**Re: Defect Information Report – Supplemental Report No. 3  
07V-302, FL-504, Bendix SR-7 Spring Brake Control Valve Assembly Check Valves**

Subject: RECALL 07V-302– Bendix SR-7 Park Brake Valves

January 2008  
 FL504A-G  
 NHTSA #07V-302  
 REVISED NOTICE

**Fig. 1, External Check Valve Identification**

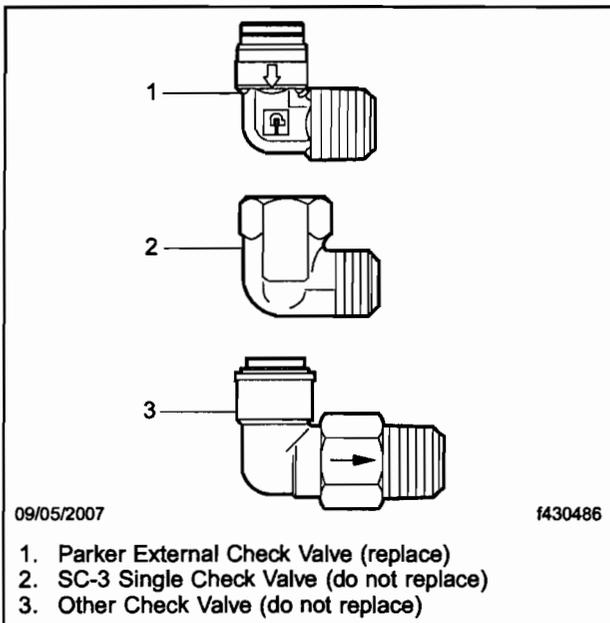
2. Locate the SR-7 spring brake modulating valve on the vehicle. Typically, it is located near the rear axle, mounted on the frame rail or cross member.
3. Locate the Parker external single check valve installed in the supply port of the SR-7 valve as shown in Fig. 1.

**Fig. 2, Inspecting the Parker External Check Valve**

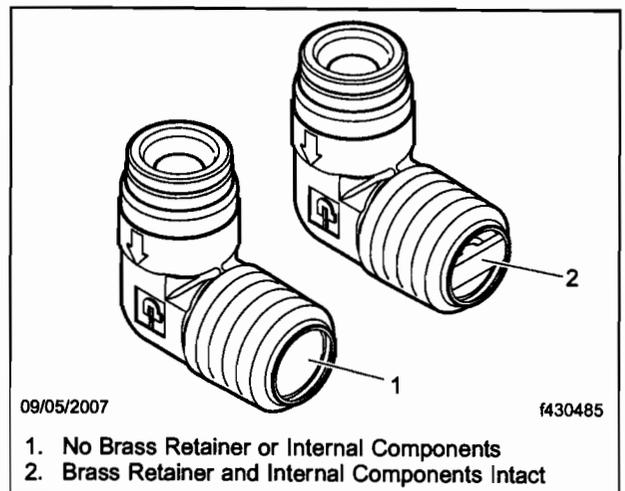
4. Remove the 1/2-inch o.d. supply line from the external single check valve supply port.
5. Note the orientation of the external check valve. (Some SR-7 valves may have a fitting between the external single check valve and the SR-7 valve.)
6. Remove the external single check valve.
7. Inspect the outlet (threaded side) of the Parker single check valve to determine whether the brass retainer and internal components are present and intact. See Fig. 2.

If the brass retainer and internal components are present and intact, go to the next step.

If the brass retainer and internal components are not present and intact, both the Parker external check valve and the entire SR-7 valve must be replaced. First complete the "SR-7 Valve Replacement" below then continue with this procedure and install the external check valve kit.

**Fig. 3, Replacing the Internal Check Valve**

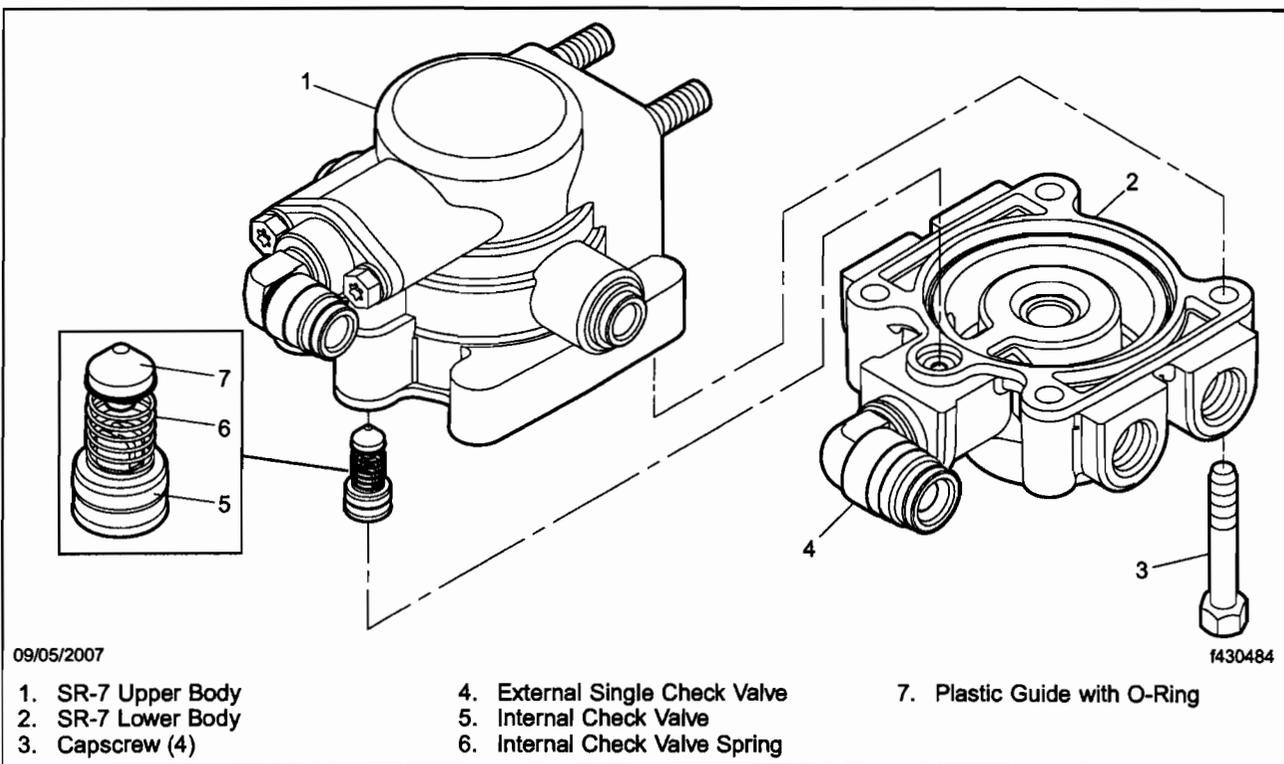
1. Ensure that the vehicle is properly chocked, then drain the air system.
2. Remove the four screws that secure the upper and lower bodies of the SR-7 valve. See Fig. 3. Do not disconnect additional hoses or fittings. The separation between the upper and lower body should be approximately three inches and allow adequate room to install this kit.
3. Locate the plastic guide in the upper body of the SR-7 valve directly above the supply port. The O-ring seal from the lower body may stick to the plastic guide when the bodies are separated. If so, remove it from the guide and place it back into the lower body. An extra O-ring has been included in this kit in the event that the O-ring is lost or damaged during servicing.

4. From the valve bore, remove and discard the plastic guide, spring, and check valve.
5. Insert the replacement cartridge in the bore where the check valve, spring, and plastic guide were removed. Push the cartridge into position until it stops. A portion of the plastic guide in the cartridge will stick out. Do not force the cartridge further into the bore.

**Fig. 4, Date Code and Casting Number Identification**

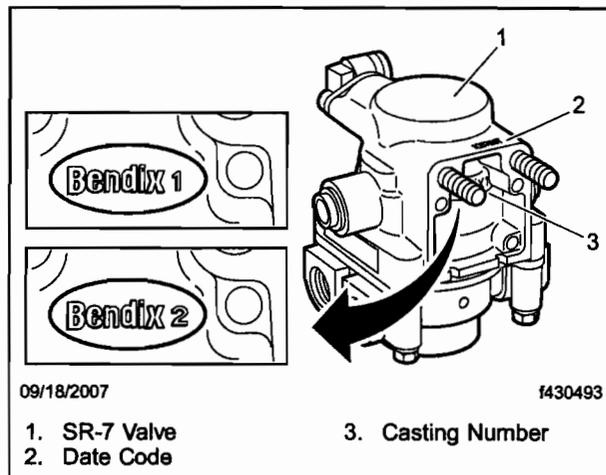
- Locate the manufacturing date code on the top of the SR-7 valve. See Fig. 4 to determine its location.

In the date code, the second character is a letter representing the month of manufacture (affected months are D = April and E = May; no other months are involved). The next four characters are numbers; the first two represent the day and the second two represent the year. For example, the date code 1D2006T indicates the valve was manufactured April 20, 2006.

If the date code is **not** between April 1, 2006 (D0106) and May 24, 2006 (E2406), no further work is needed.

If the date code **is** between April 1, 2006 (D0106) and May 24, 2006 (E2406), install the internal check valve kit. Go to the "Internal Check Valve Cartridge Replacement" procedure.

1. Without removing the air lines and fittings at this time, carefully remove the mounting nuts and move the valve away from the bracket to view the back.
2. Inspect the casting stamp between the mounting studs on the back of the valve. Either "Bendix 1" or "Bendix 2" is stamped on the valve. See **Fig. 4**.
